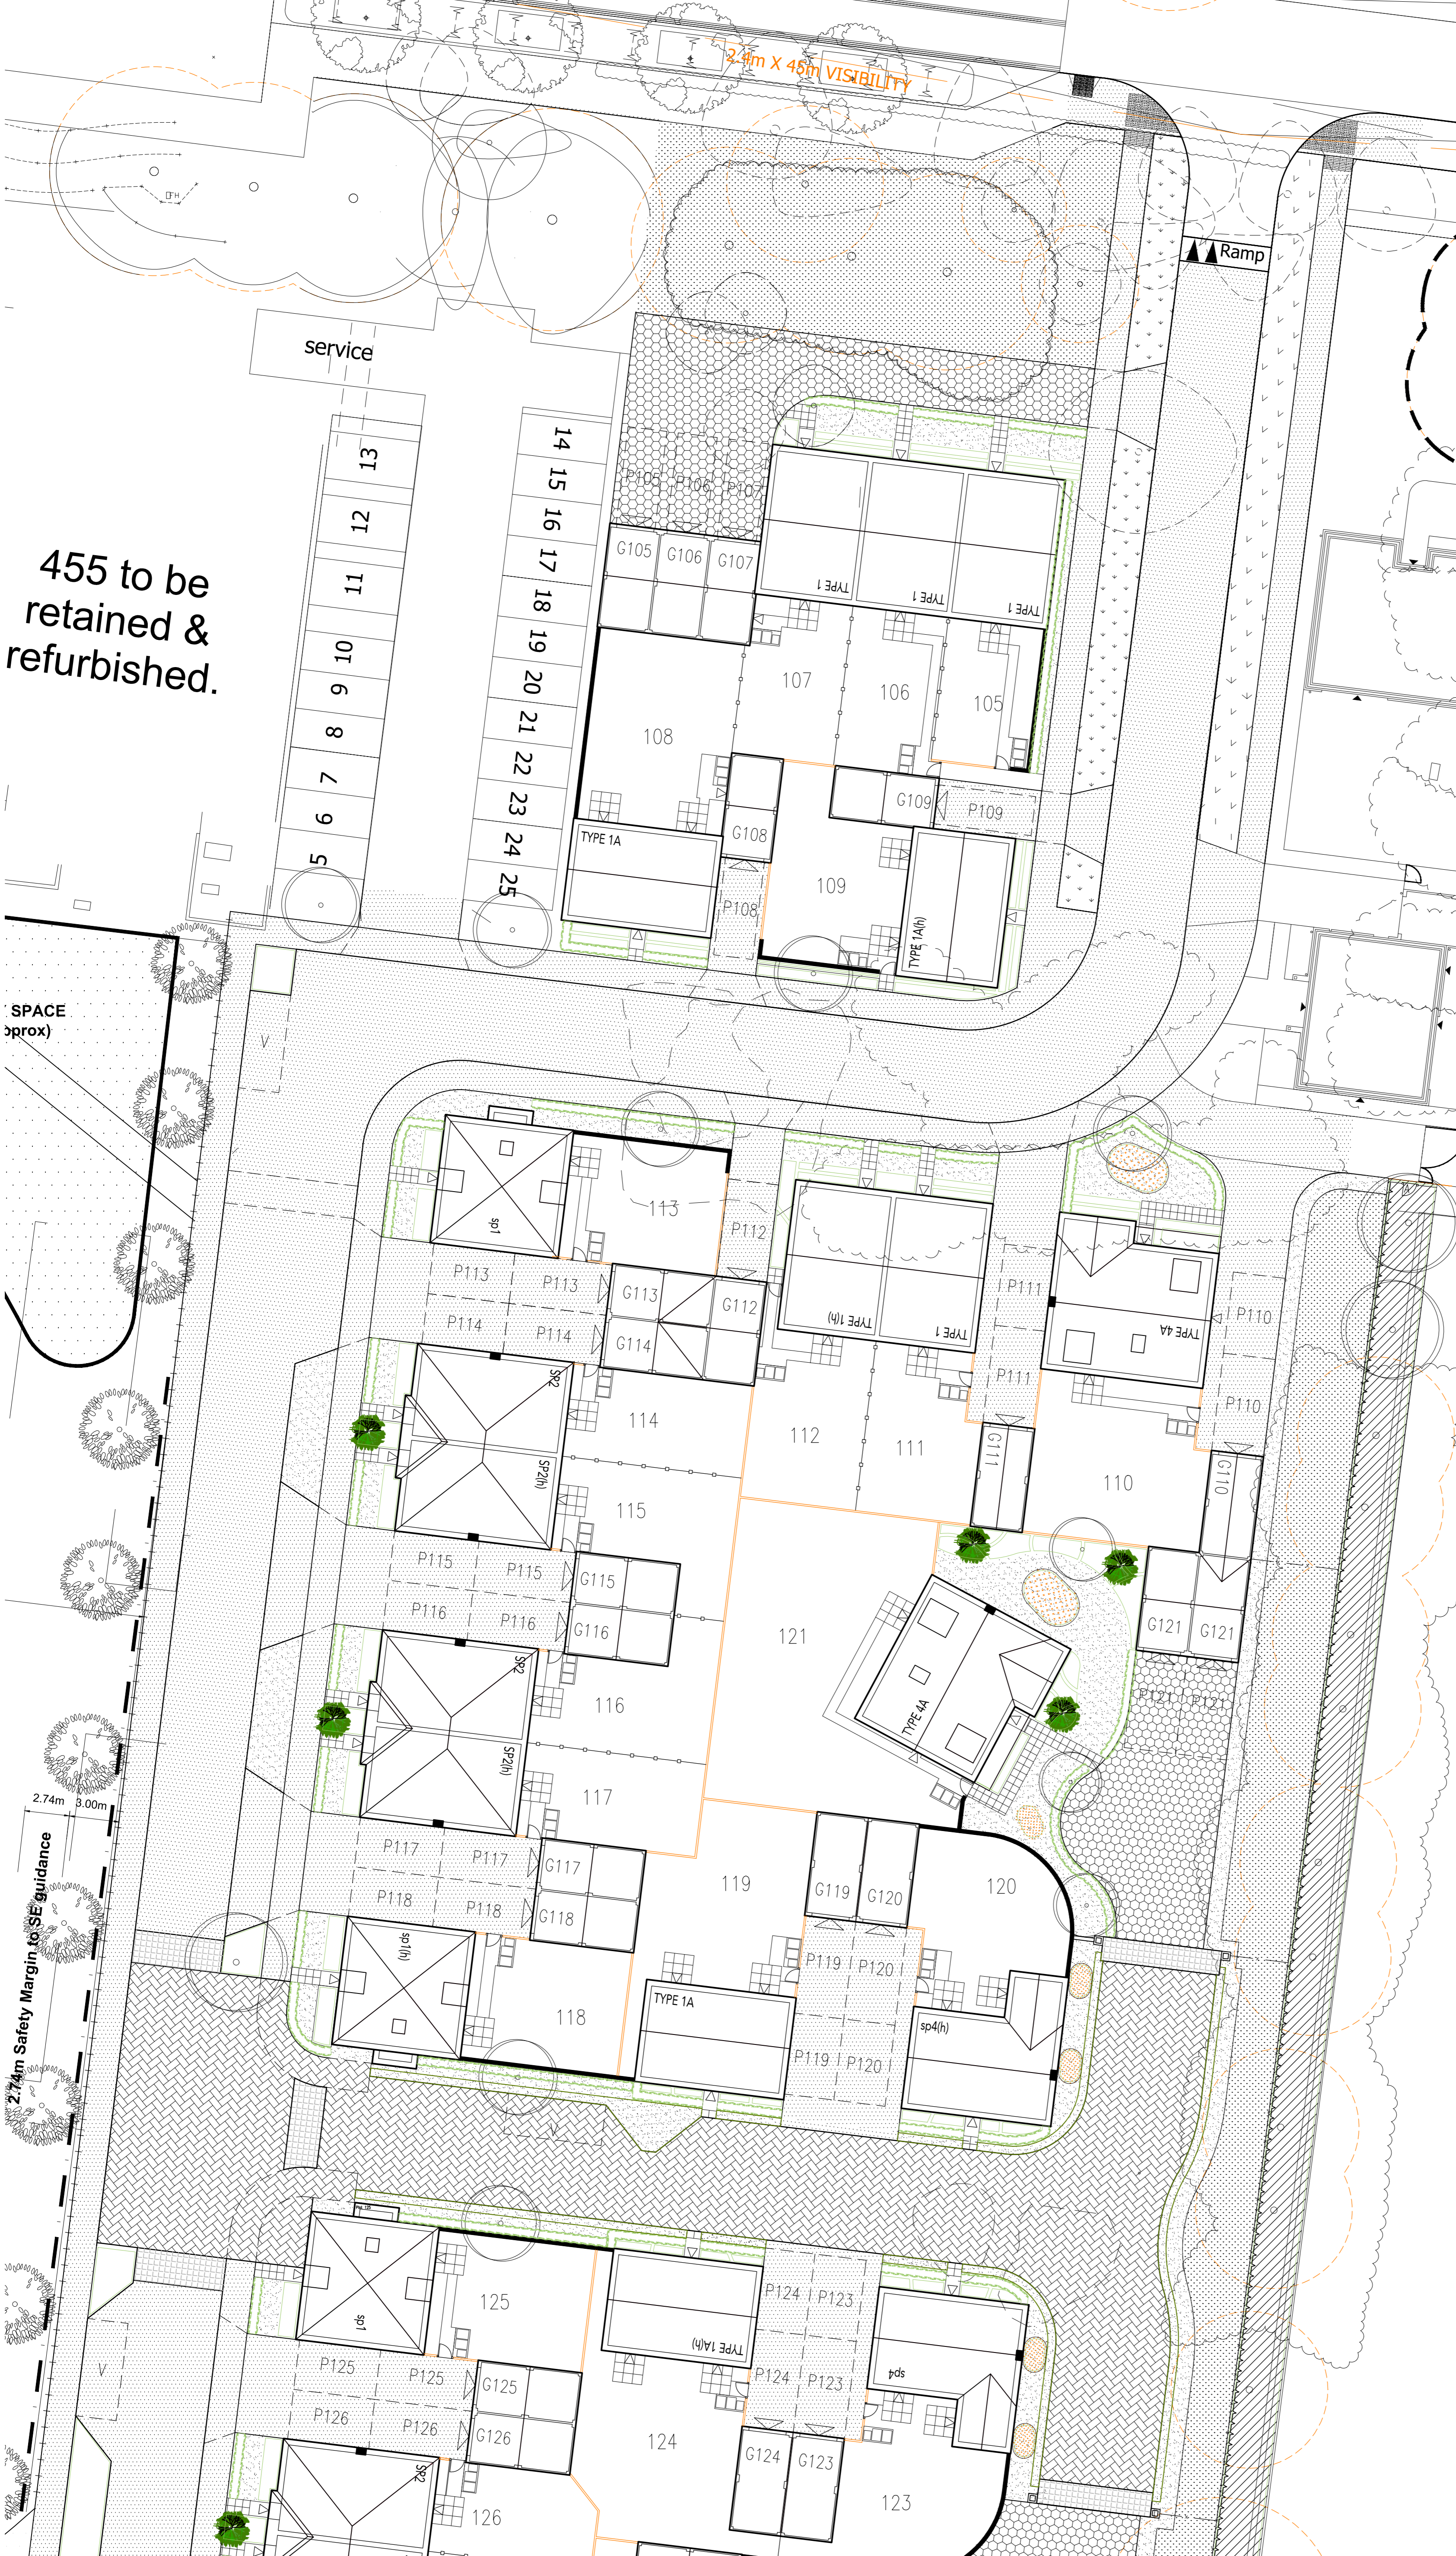
- A. 2014-10-20. Plots 9-14, 21-26 & 37-39 re-positioned and road layout in-front of those plots redesigned, sub-station relocated, gravel surface added on the private drive in front of plots 1-3 (now 105-107), shingle/stone rolled tarmac added on the private drives village green design updated, plots 6, 17, 18 swapped with type 4A and side access to plot 29 amended, Plot 20 & 36 handed and plots 1-50 renumbered as 105-154 to suit with other parcels following Local Authority's comments. SRS

- B. 2014-10-29. The frontal projections on plots 114-117, 126-129, 142 & 149 made 300mm wider, garages for plots 115-118, 125-130, 141 & 42 made eaves fronted, roof form on plots 112-114 changed, plot 139 re-aligned and plot 109 handed following Local Authority's comments. SRS

- C. 2014-11-11. The footprints for SP1 on plots 113, 118, 125, 130, 131 & 141 made 350mm wider & deeper, plots 119 & 124 repositioned and the extra visitor's space in front of plot 113 taken off, following client's request. SRS

- D. 2014-11-23. Plot 122 is re-positioned & substituted with a SP5, plot 138 is substituted with a Type 1A, plot 140 is substituted with a SP1, plots 134 & 154 is substituted with a rear version of Type 1A and necessary layout amendment carried out following these amendments, as per Local Authority's comments. SRS

- E. 2014-12-05. Plots 122, 133-135, and 154 repositioned to avoid existing trees at Tree Officer's request. Display of visibility splay with Camp Road clarified. DJE

- F. 2015-01-09. Title amended to Phase 3 from Phase 2 at client's request. AJA
- G. 2015-01-23. Bay window removed from house type 4A. Block Paving specification added. Loose stone grid system added in lieu of stone rolled tarmac. All at client's request. DJE

- H. 2015-02-18. Display of Close Board Fence amended at client request to improve clarity. DJE
- I. 2015-02-24. 1500mm high post & rail access gate added to the managed vegetation area at the eastern boundary, 1500mm high extra post & rail fences added along the plots to the eastern managed vegetation area and boundary extend for plot 134 extended while removing the screen wall and adding 1500mm high post & rail fence along the eastern managed vegetation area, following client's request. SRS

- J. 2015-04-07. Paved areas in front of plots 118, 125 and 141 amended, appearance of tarmac hatching adjusted, 1800mm high pier amended and low wall removed in front of plots 148 and 149 all at Client request. MED

- K. 2015-06-05. Legend updated to indicate patios as 450x450 Marshalls buff slabs. AJA
- L. 2015-10-26. Roads by Plots 118-125 and by Plots 130-134 & 139-141 widened to 8m overall. Junctions amended. All to match construction details. DJE

- M. 2015-12-03. Road by Plots 113-118 and 125-130 amended. Boundary updated. DW
- N. 2016-02-18. Landscaping updated to front of Plots 118, 125 + 141. Brick piers, rumble strip and low screen wall to Plot 121 adjusted to match as built survey received 2016.02.17, landscaping adjusted to suit. EMB

- O. 2016-02-26. Buildouts repositioned and on-street parking spaces amended along the road west of the site. Position of the piers to the side of Plot 123 adjusted, the buildouts and visitor bays by plots 114 - 116 removed at client's request. PVA

- P. 2016-03-10. Buildouts by Plots 114-117 added. Road alignments by Plots 130 and 148 amended. All to suit latest Woods Hardwicke scheme. DJE
